Work Order ID 104839

Item ID: D407-667-205

Item Name: Aft Crosstube

DRAWING NO. D407-667-245	TITLE CROSSTUBE ASSY (407 HIGH AFT)	REV. F	DART AEROSPACE LTD ENGINEERING ORDER		D.E.O. NO. D407-667-245-F-1	SHEET NO. SHEET 1 OF 2	SCALE NTS
DRAWN	CHECKED	MFG. APPR.	APPROVED	DE APPR.			
DATE 11.04.08	DATE 11.04.12	DATE 11.04.12	DATE 11.04.12	DATE 11.04.12	DATE 11.04.12

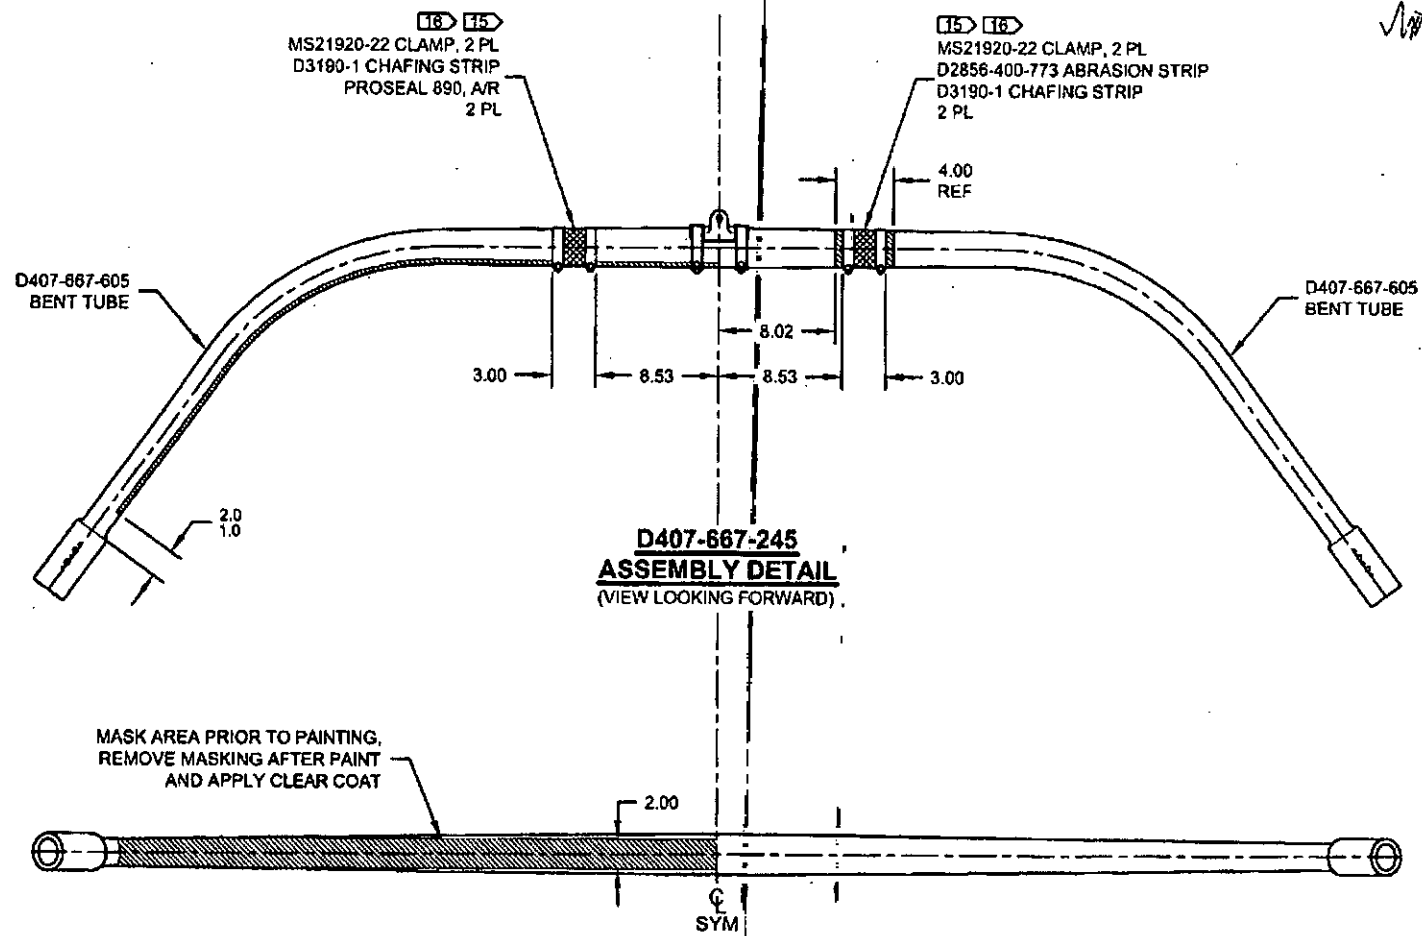
CHANGE:

NOTES 2 AND 15, SHEET 1 ARE AMENDED AS FOLLOWS:

- 2) FINISH: CHEMICAL CONVERSION COAT PER DART QSI 005 4.1
PRIME INSIDE AND OUTSIDE PER DART QSI 005 4.2
MASK UNDERSIDE OF CROSSTUBE AS SHOWN (HATCHED AREA) AND
PAINT OUTSIDE PER DART QSI 005 4.2
REMOVE MASKING AND APPLY CLEAR COAT
- 15) APPLY A THIN COAT OF PROSEAL 890 ON INSIDE CONCAVE SURFACE OF D3190-1
CHAFING SHIELDS AND LET CURE PER MANUFACTURER'S INSTRUCTIONS. INSTALL
PROSEAL D3190-1 CHAFING SHIELDS ONTO CROSSTUBE BY APPLYING A THIN COAT
OF PROSEAL 890 ONTO CROSSTUBE. BE SURE TO ELIMINATE ANY AIR GAPS.

IS:

WAS:
